Lower Thames Crossing

9.69 Final Agreed Statement of Common Ground between (1) National Highways and (2) Harlex Haulage and (3) J & B Martin (Crayford & Fawkham) Limited (Tracked changes version)

Planning Inspectorate Scheme Ref: TR010032
Examination Document Ref: TR010032/EXAM/9.69

Status	Fit for Information	Original Size	A1	Revision	P01.3
Application Document Number					
Drawing title	Harlex Haulage Access Vehicle Tracking				
Drawing Number	HE540039-CJV-BOP-ZZZ_ZZZZZZZZZZ-DR-CH-00003				
Scale	1:500

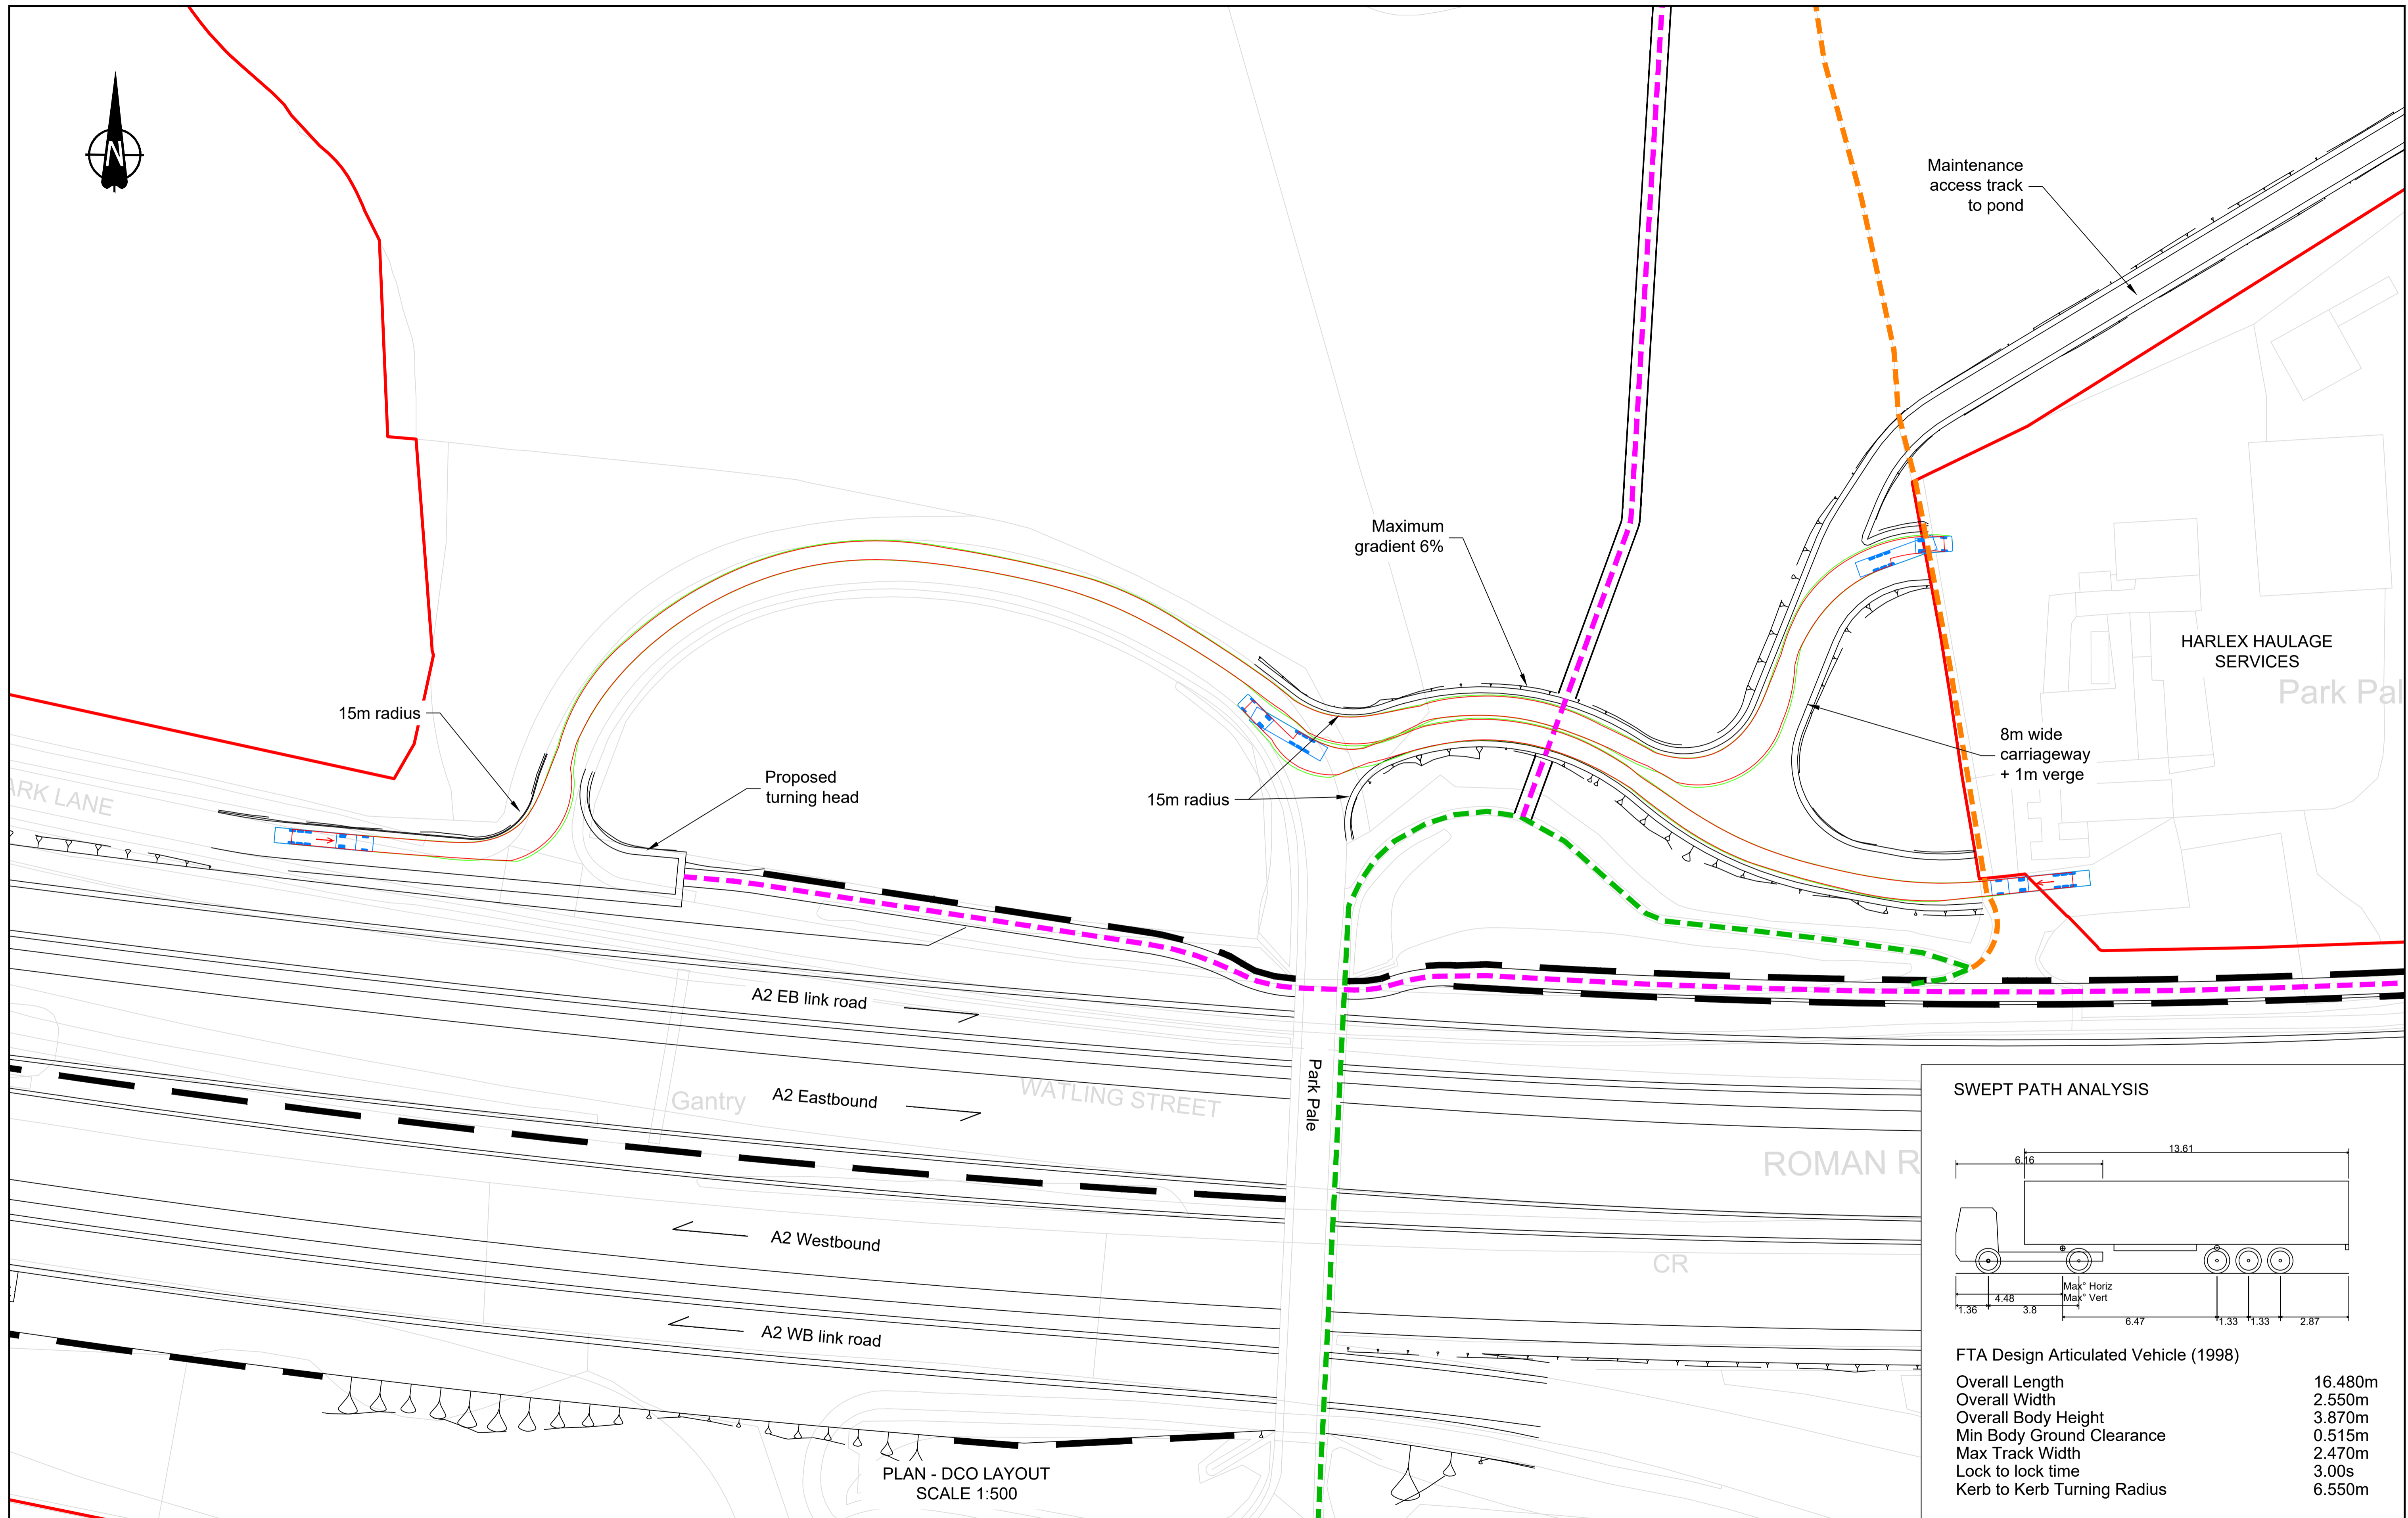
Topic	Item No.	Harlex Haulage Limited, and J & B Martin (Crayford & Fawkham) Limited Comment	The Applicant's Response	Application Document Reference	Status
Replacement Access – Updated Entrance & Exit Design Request	2..1.3	<p>Harlex propose a new updated entrance and exit design for the replacement access. The reason for this request was that there was no alternative and that the Applicant had not appreciated the design requirements during early design.</p> <p>The interested party remains sceptical the sweep paths and vehicle tracking will work in practice from Park Pale Road and into the haulage yard</p>	<p>The current design (Work No 1C as shown on Sheet 3 of the Works Plans) was proposed by Harlex and accommodated by the Applicant at Community Impacts Consultation (June 2021). The Applicant has undertaken vehicle tracking and shared the same demonstrating articulated vehicles, measuring 15.5m in length, can navigate the replacement access in its current design. Please refer to Appendix B.</p>	<p>Works Plans Volume B Composite [Document Reference 2.6 Volume B Composite (6)]</p>	Matter Not Agreed

<p>This further request to change the design, as illustrated in Appendix C, received on 7 February 2023, will have many impacts and the Applicant has a number of design concerns over the design of the access proposed by Harlex. Splitting the carriageway until the junction will lead to vehicles entering and exiting the junction on the wrong side of the road (as Harlex switch their direction of one way operation), which would be a safety risk. The current design ensures that all vehicles are on the correct side of the carriageway at the junction. As the access will also be used by the Applicant for maintenance of ponds, it would also mean that maintenance vehicles would either have to travel against the flow of traffic or go through the Harlex site to</p>

Topic	Item No.	Harlex Haulage Limited, and J & B Martin (Crayford & Fawkham) Limited Comment	The Applicant's Response	Application Document Reference	Status
			<p>avoid conflict. Splitting the carriageway also means pedestrians using the footpath will have to cross two carriageways which is avoided in the current proposal. It may also need to be consulted on and will incur additional cost (compared to current design) and introduce consultation uncertainty.</p> <p>The replacement access to Harlex Haulage is a private/maintenance access track; therefore, it does not fall under the requirements of the Design Manual for Roads and Bridges (DMRB). However, to promote a conservative design approach at this stage of preliminary design, DMRB CD 123 recommendation at clause 5.2 has been considered: <i>“Allowance shall be made for the swept turning paths of the worst case design vehicle which is expected to use the priority junction.”</i></p> <p>The worst case scenario was not available at the time of the design; therefore, a standard design vehicle has been used in accordance with DMRB CD 123, which states: <i>“The design vehicle for at-grade priority and signal controlled</i></p>

Topic	Item No.	Harlex Haulage Limited, and J & B Martin (Crayford & Fawkham) Limited Comment	The Applicant's Response	Application Document Reference	Status
			<p><i>junctions is a 16.5m long articulated Heavy Goods Vehicle.</i></p> <p>As noted under paragraph 5.6.2 in DMRB CD 123: <i>"At simple priority junctions where provision is made for the design vehicle, the corner radii should be 15 metres in rural areas followed by a corner taper of 1:10 over a distance of 25 metres."</i></p> <p>The uses of this junction will be limited to Harlex Haulage and National Highways maintenance vehicles only. Members of the public and general road users should not be using this access; therefore, this is a private means of access. As this junction does not sit on the Strategic Road Network nor form a through route the design has been developed to safely fit within the surrounding constraints.</p> <p>With all the considerations above, it is therefore concluded that the design of the access to Harlex is safe and in line with good practice and current standards.</p>
